CITY PLANNING COMMISSION

B. Plan review of a proposed 29,950 sq. ft. mini-storage building addition on 2.8± developed acres in the General Commercial-Review Executive Airport Overlay (C-2-R-EA-1 and EA-2) Zone.

LOCATION: 1353 Florin Road

APPLC. NO. P88-478 MEETING DATE February 23, 1989 ITEM NO. 4

ELEVATIONS

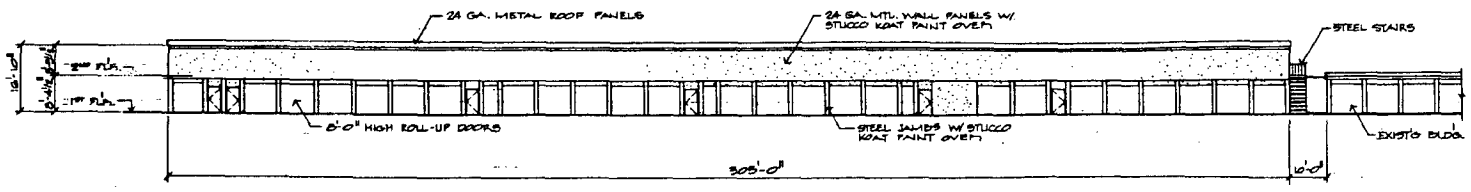
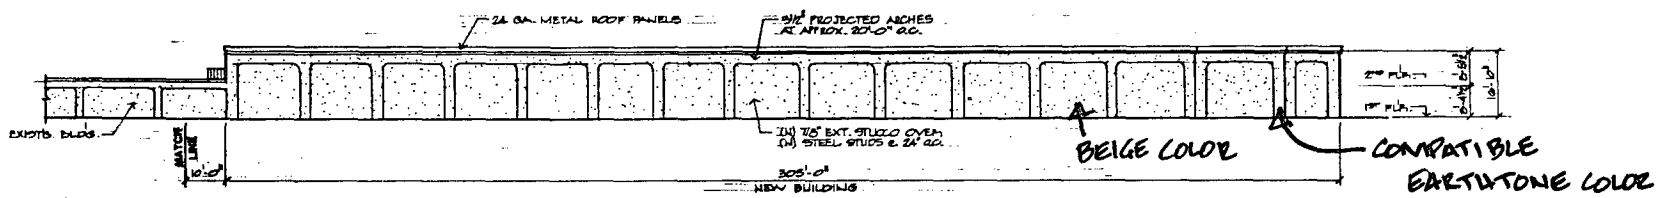
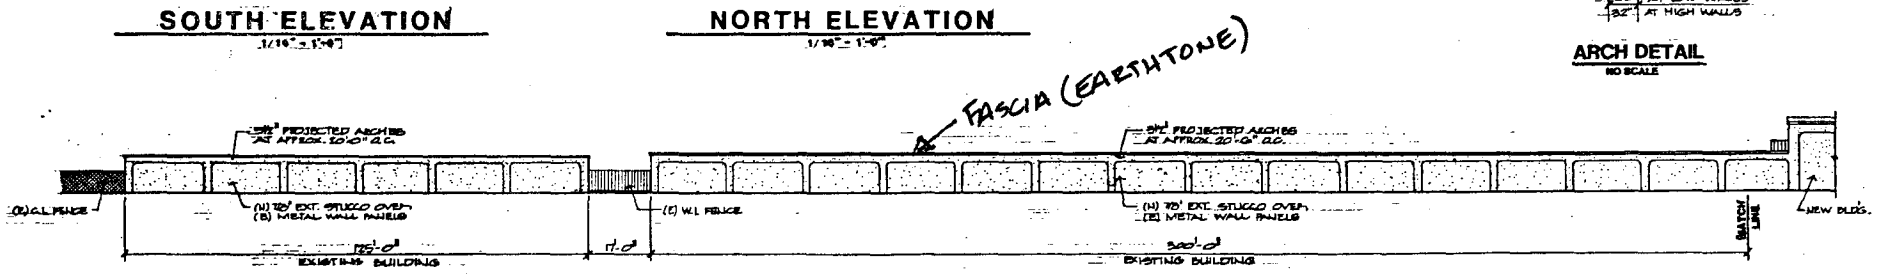
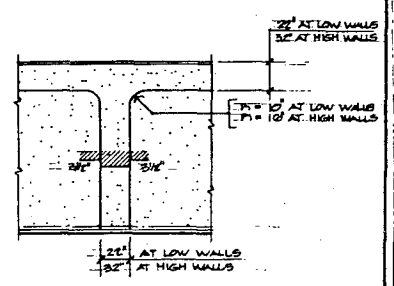
6. The applicant shall adhere to the attached building elevations which indicate the use of stucco-coat paint over metal wall panels on the east elevation and the use of an arch design made from stucco on both west elevations. All new stucco and stucco-paint applied to both existing and proposed buildings shall be painted a beige color with the archways painted a compatible earthtone.
